то:	Olivia Whittaker, P.E., CFM
CC:	David Phan, P.E., CFM
FROM:	Jeremy D. Dixon, P.E., CFM, Maria C. Velazquez, E.I.T., CFM
SUBJECT:	FP23-04 – 6050 Belt Line 2 nd Submittal
DATE:	February 5, 2024
PROJECT:	DWU22105 - Dallas Floodplain Reviews

Freese and Nichols, Inc. (FNI) has reviewed the second submittal of the Fill Permit Application dated October 2023 by Kimley-Horn and Associates, Inc., (KH). FNI received the submittal from the City of Dallas (City) on February 5th, 2024, and included a Fill Permit Application form, a Fill Permit Application, H&H Models and Drawings. The Fill Permit Application was previously reviewed by the Dallas Water Utilities (DWU), providing comments to KH on August 25, 2023. City requested that FNI review and confirm no major errors with the review process and the submittal provided.

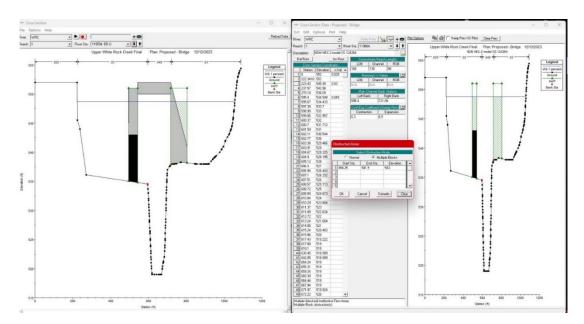
3. In the proposed conditions model for the scenario without a bridge, cross section 119591 (referenced below) was eliminated. This was done to ensure that there were no negative alterations between the revised existing and proposed conditions results, in the event that the proposed grading for the pedestrian bridge is excluded. This modeling preference did not alter the final conclusion.

4. In the proposed conditions scenario that includes a pedestrian bridge, the blocked obstruction at cross section 119664 (referenced below) was eliminated. This modeling preference did not alter the final conclusion.
